Subject: PEFS F3 Pressure Switch Monitoring

Product: PEFS F3 systems

Chubb Information Bulletin

Issue No: IB201905

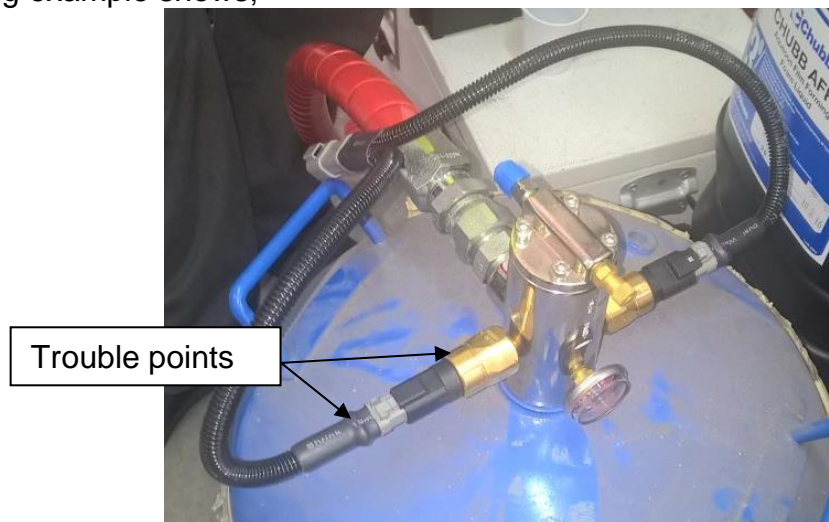
The pressure switch Chubb supplies with the PEFS F3 system was chosen because of its quality and accuracy (tolerance & hysteresis). After several reports of low pressure alarms, a random sample of stocked switches were tested.

Result: All switches tested within tolerance for both rising and falling pressures.

Action: None

Table 14 - PEFS F3 cylinder charging pressure versus ambient temperature

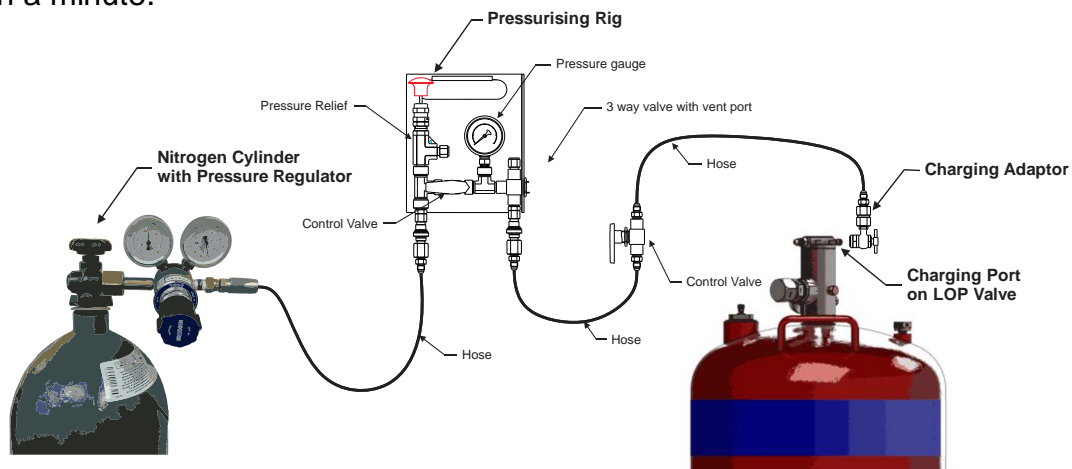
In the above example, if the ambient temperature was to drop 20°C overnight, the system pressure is likely to also drop back to 1633kPa. However if the system was pressurised to 1700kPa when it was 30°C then if the pressure was to drop 20°C overnight then the monitoring panel is likely to indicate a low pressure warning.

Result: More detailed pressurising instructions has been added to the PEFS F3 product manuals in consideration of temperature changes and their acute effect on pressure. When pressurising a LOP system it is important to use an in line gauge and leave the pressure source connected after the working pressure is reached for no less than a minute.

Action: Care must be taken to ensure system is pressurised to correct operating pressure.

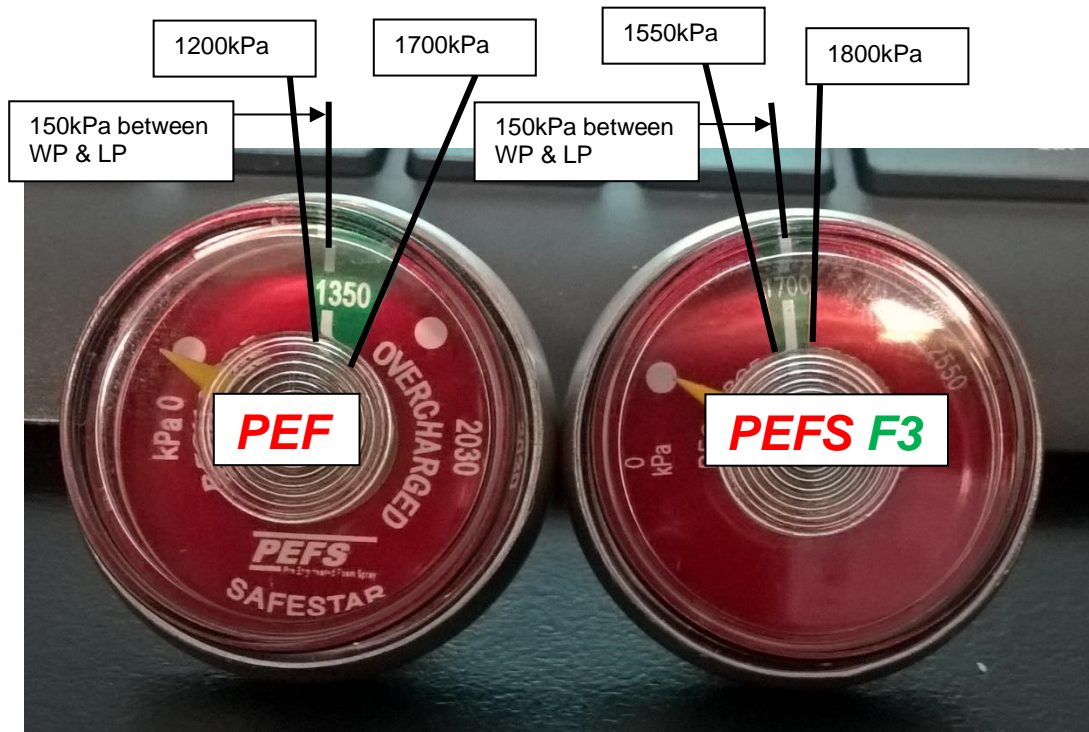
The new PEFS F3 pressure indicator has the same 150kPa pressure gap between operating pressure and low pressure that the previous PEFS system had. The end of the green sector (left side) indicates the pressure at which the low pressure switch will operate.

The PEFS F3 indicator does not have the same gap between operating pressure and the end of the green sector as the previous PEFS system had. See example below.

Result: If a system is not pressurised in accordance with the recommendations provided in our manuals and/or a significant temperature change occurs in a short period of time, there is a possibility that a “low pressure” alarm will activate.

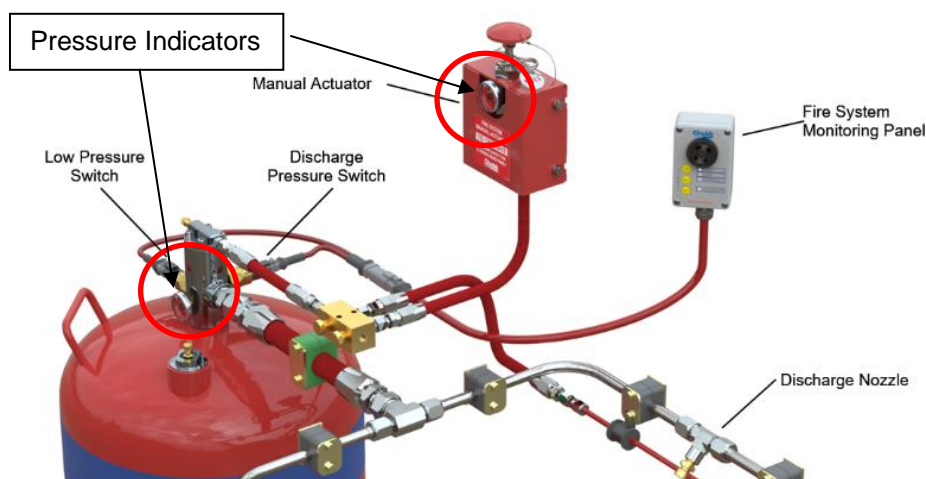
LOP systems can also be installed with multiple pressure indicators (see below) but due to the effects of temperature, age and tolerances, not all of the indicators may read the same pressure. A wide green band or (pressure tolerance) is always needed in this application.

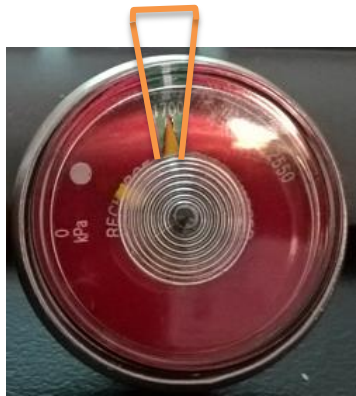
Action: Temperature testing has been carried out in our factory and the results show that without a larger tolerance area on the overcharge side of the indicator, 150kPa may not be enough of a gap between operating pressure and low pressure alarm for this application.

To increase the gap, more fire performance testing needs to be carried out on all of Chubb's cylinder sizes at even lower pressures. This project is currently underway and some successful results have been obtained at a lower pressure of 1450kPa (Testing is still ongoing).

Until a permanent solution is deployed and where continual nuisance faults are being experienced, the PEFS 1450kPa (Part No. 87067) switch may be substituted for the PEFS F3 1550kPa switch. In extreme conditions the PEFS 1200kPa (Part No. 87066) switch may be used.
